STAFF REPORT

SUBJECT: H-2022-0004
Alamar Subdivision

LOCATION: The site is located at 4380 W. Franklin Road (Parcel #S1210346603), near the northeast corner of N. Black Cat Road and W. Franklin Road, on the north side of Franklin Road, in the SE 1/4 of the SW 1/4 of Section 10, Township 3N, Range 1W.

D. Phasing Plan (dated: ~~March 15~~ May 30, 2022)

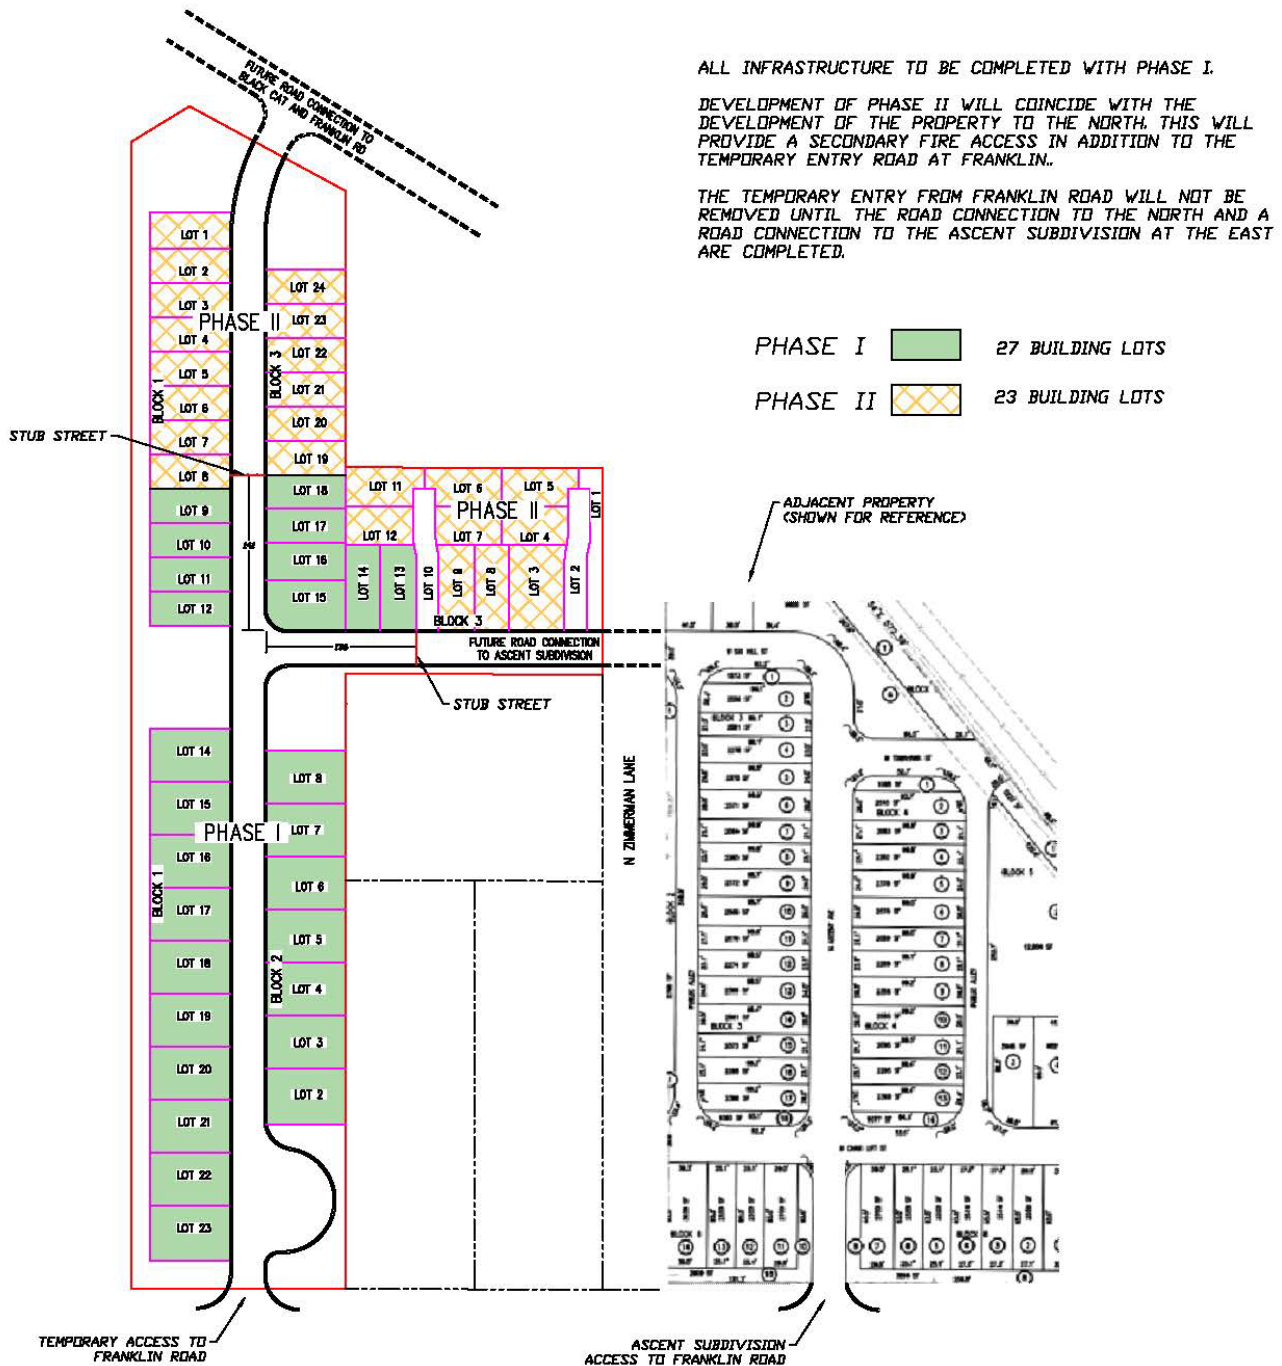
with an average lot size of 2,762 square feet. According to the submitted plans, the plat is currently proposed to develop in two phases due to the available access to the site being only from Franklin Road at this time. The phasing plan depicts construction of 22 building lots in the southern half of the site with three open space lots (including the largest centralized open space lot) in Phase 1 with the public roads terminating less than 150 feet from the internal intersection—thus, 20 of the 21 detached single-family lots and two single-family attached lots are proposed in Phase 1. Phase 2 then depicts the remaining building lots to the north and east of the centralized intersection to be constructed along with some remaining open space lots along the north boundary.

Further, Phase 2 depicts the north-south local road within the site terminating at the north boundary over the Purdam Gulch stub drain with a slight curve to the northeast to match the property line. Staff has had multiple discussions with this Applicant and the Developer of the Zimmerman property to the north in regards to the proposed termination of the north-south local street within this development. The issue that has been brought up is the preferred alignment of this street at the north property line and consequently where it would connect to the extension of W. Aviator Street, the collector road required to be developed with the project to the north. Staff notes it has been the City's practice to require an Applicant change their road alignment based upon conceptual drawings of a project that has not yet submitted to the City. **However, Staff has included a DA provision to allow this Applicant the flexibility to revise the road alignment and lot layout with the future Phase 2 final plat should they be able to work out a mutually beneficial agreement with the adjacent property owner; this is predicated on IF the property to the north receives approvals from the City. This recommended provision *does not* require this Applicant revise their plat at any point but its intent is to provide flexibility to the Applicant to make any necessary revisions to the plat without having to go through the hearing process for subsequent changes that do not increase the number of building lots or drastically change the project design but help the overall road network in this area of the City.**

- a. Ability to modify the phasing plan to allow additional lots within pahse 1 should a road connection occur to the east prior to the connection to the north.

- a. Future development of this site shall be substantially consistent with the approved plat, landscape plan, phasing plan, and conceptual building elevations and floor plans included in Section VII and the provisions contained herein, except that phase 1 may be modified to include additional building lots on the 1-acre east leg of the project should a public road connection to W. Atomic Street occur.

E. Conceptual Building Elevations (dated: March 15, 2022)

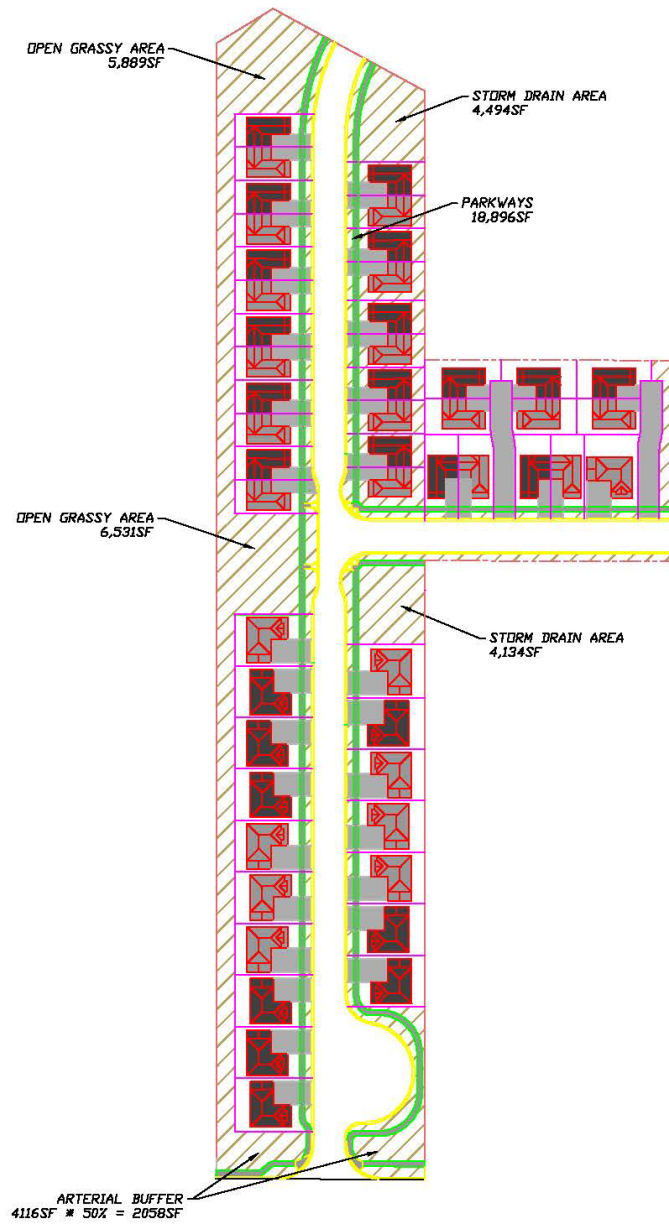
The proposed residential units are all front-loaded but show a garage that is set back from the living area façade facing the internal local street. The submitted elevations and conceptual floor plans are not dimensioned but the garages appear to be considerably behind the living area facades. This design provides for a more porch dominated street façade compared to traditional single-family residential, as desired. Staff is including a DA provision to ensure this type of design is maintained for the project.

Conceptual building elevations and first-floor floor plans were submitted for the proposed detached and attached single-family units, as shown in Section VII.F. The conceptual elevations do not list specific materials but appear to show a combination of lap siding and stucco field materials with porches and brick or stone accent materials along the front of the homes. In addition to the elevations, the submitted conceptual first-floor floor plans depict living area and garage on the first floor with the garages set back from the living area façade closest to the street. The submitted document is not dimensioned but Staff infers that the garage doors should be at least 30 feet from the edge of the street with parkways, detached sidewalks, and parking pad between.

- c. Future development of the residential units shall be generally consistent with the required design elements outlined in the Ten Mile Interchange Specific Area Plan (TMISAP) and include second story decks on at least ~~half~~ 25% of the future residential units to better comply with the design standards.

- e. No final plat shall be accepted by the City until the Annexation and Zoning ordinance and Development Agreement are executed.
- f. All garages shall be set back at least 16 feet behind the living area façade, per the Applicant's request and consistent with the Ten Mile Interchange Specific Area Plan (TMISAP).
